Public Input No. 158-NFPA 70-2023 [Definition: Ampacity.]

Committee: NEC-P06

Photo 3 – Wall Test Fixture with Rough Wiring Installed

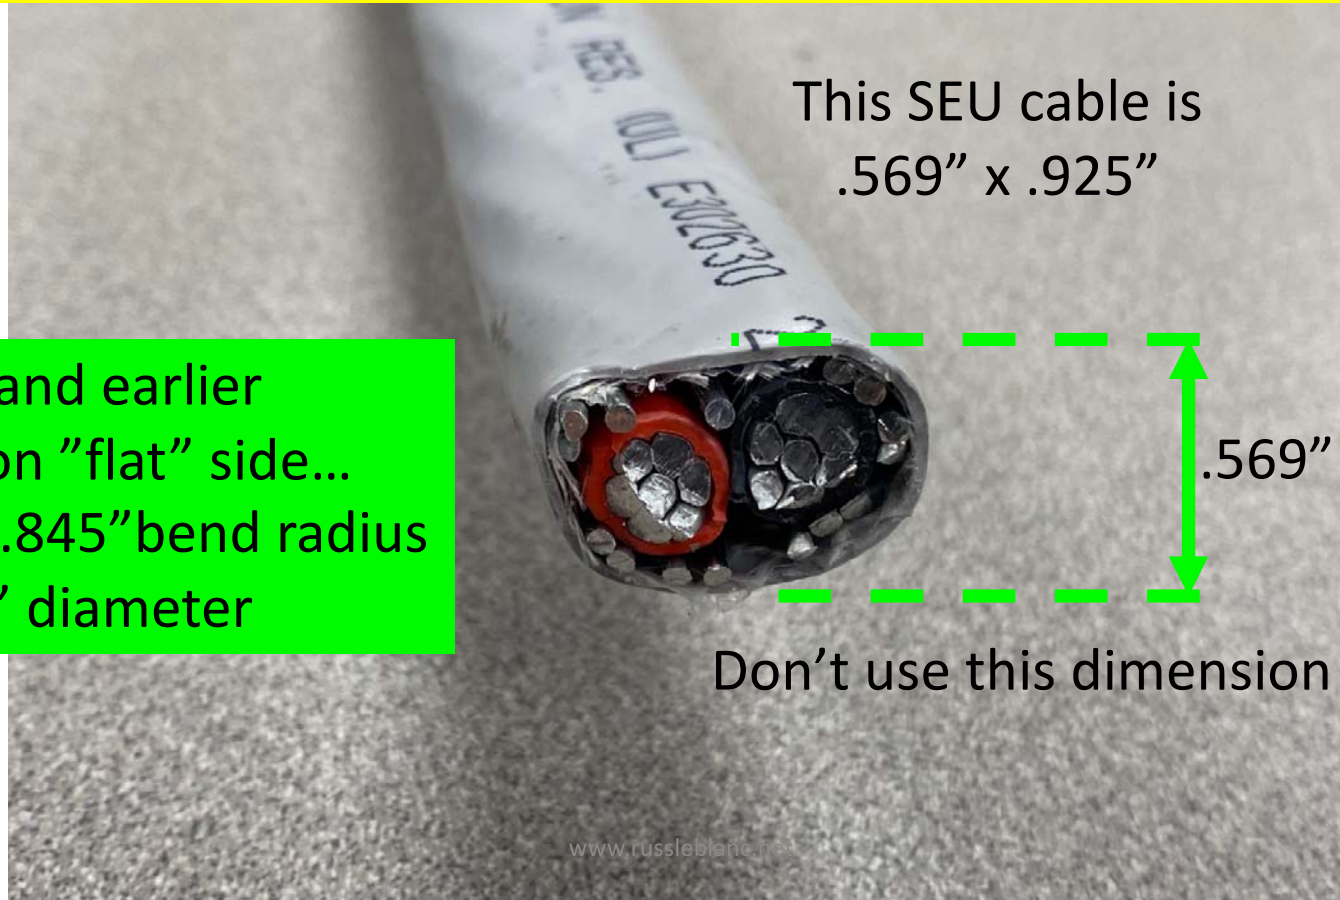
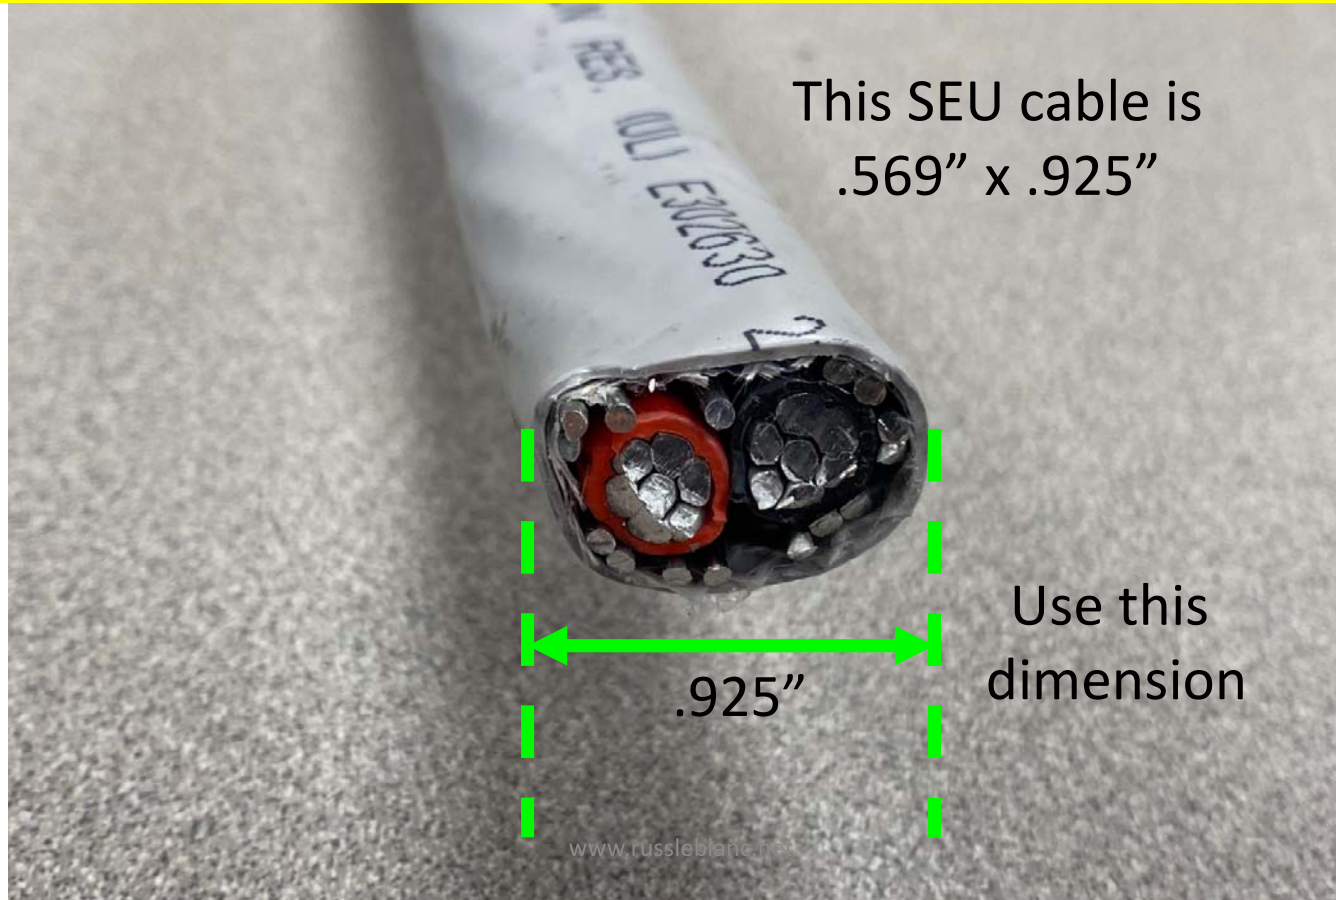
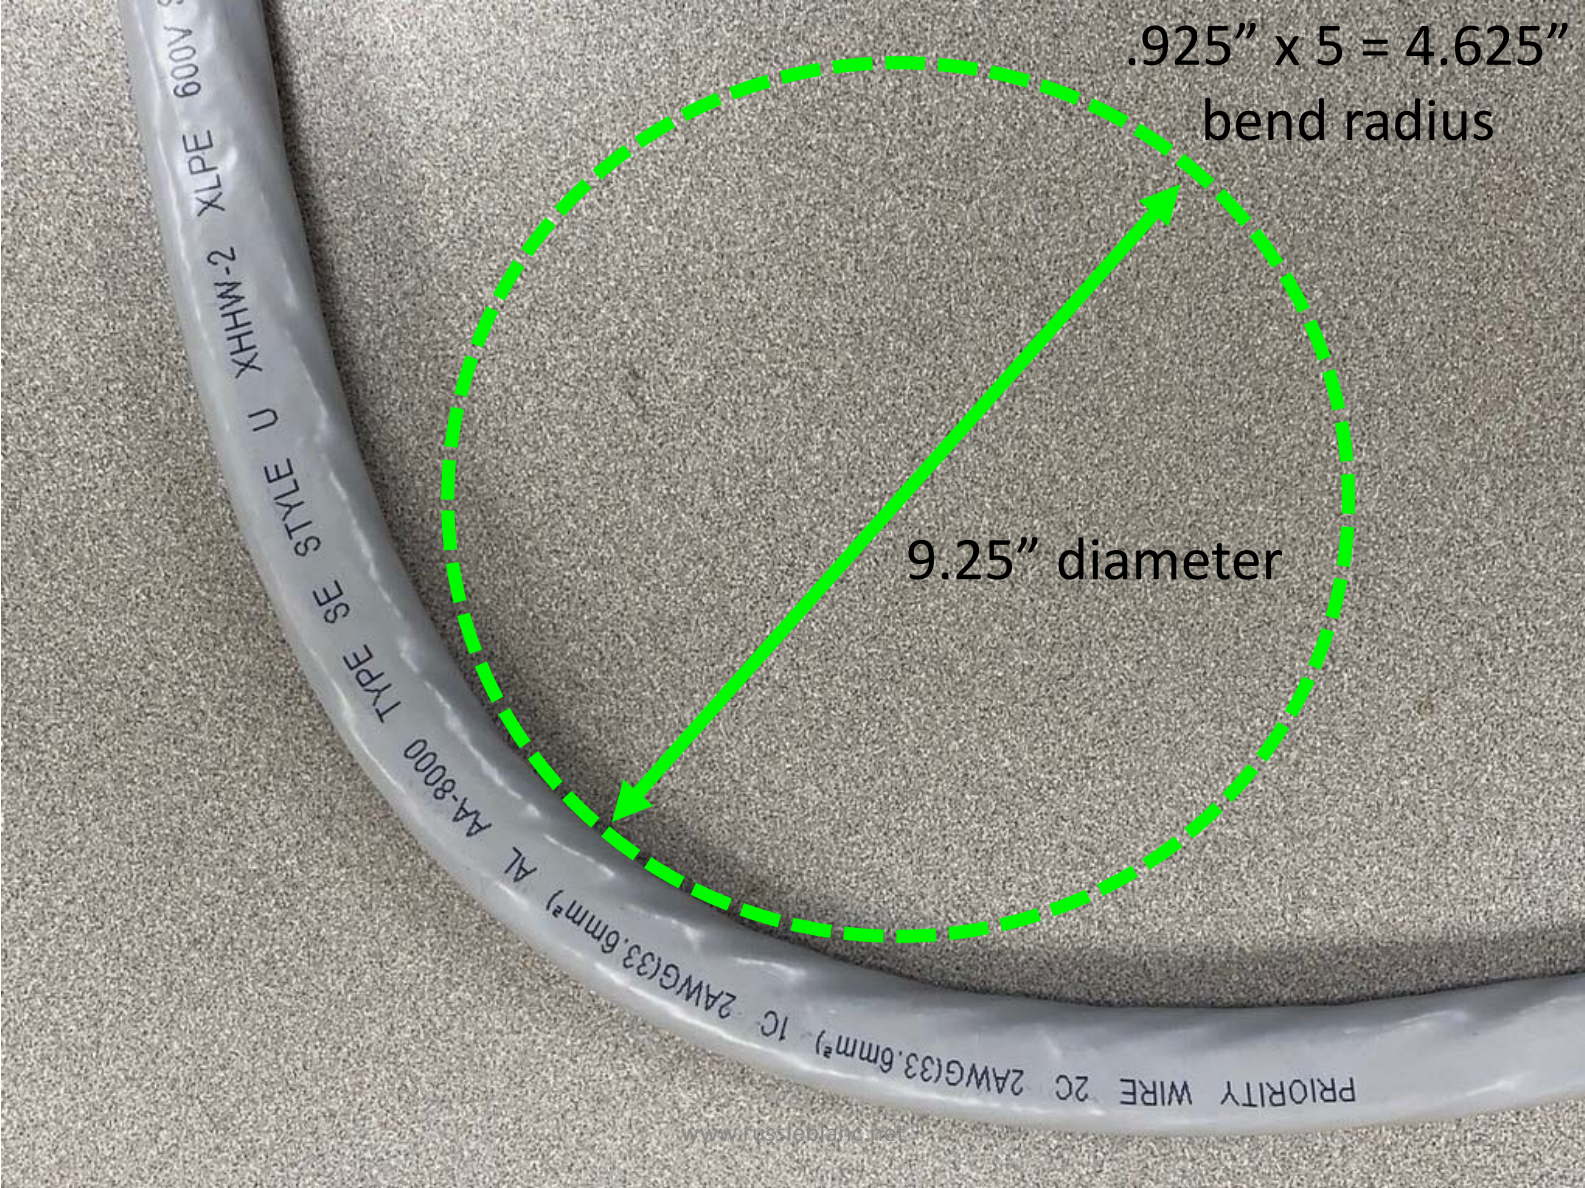
338.24- The radius of the curve of the inner edge of any bend shall not be less than five times the diameter of the cable. For flat cables, the major diameter dimension of the cable shall be used to determine the bending radius.

2020 and earlier
bending on "flat" side...
.569" x 5 = 2.845" bend radius
5.69" diameter

.925" x 5 = 4.625"
bend radius

Resolution: [FR-8121-NFPA 70-2024](#)

Statement: The revised text allows installation relief for flat cables when making bends on the flat side of the cable. The original bend radius multiplier is unaffected, thus maintaining the safety of the installation.
